Ref: **24/02889/FP - Land At Roundwood, Back Lane, Graveley, Hertfordshire.**

Thank you for consulting us on the Full Planning Permission: Residential development of 281 dwellings and associated roads, parking, realignment of Back Lane, drainage, landscaping, open space, servicing facilities and associated works.

Figure 3: End of PRow 17 Ippolyts

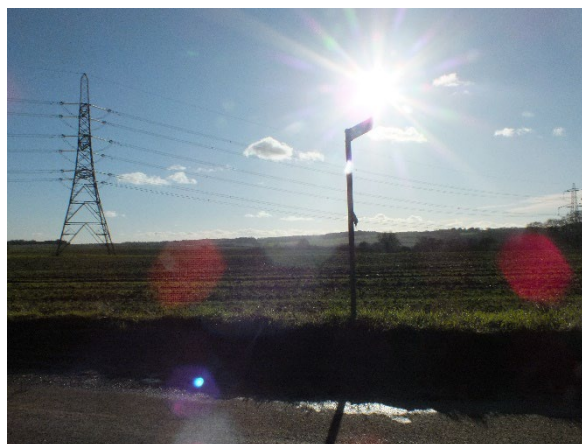
We also note that the susceptibility of **Viewpoint 2** is assessed from road users, therefore decreasing the susceptibility judged. However, we note that several similar views are also obtained from pedestrians and recreational users from PRowWs that join Sperberry Hill from the north, notably from PRow Ippolyts 17 (Figure 1 and 2).

Similarly to the west of the scheme, we advise that solar panels are set back from Sperberry Hill to allow views over the valleyside and therefore retain some of the undulating arable farmland character that is locally valuable. This will require reducing the quantity of panels to allow for these views to be retained. Whilst the alternative mitigation measures proposed of planting up the hedgerow to Sperberry Hill is not necessarily out of character, it impacts on other important characteristics which include the views of the 'large scale rolling landform'.
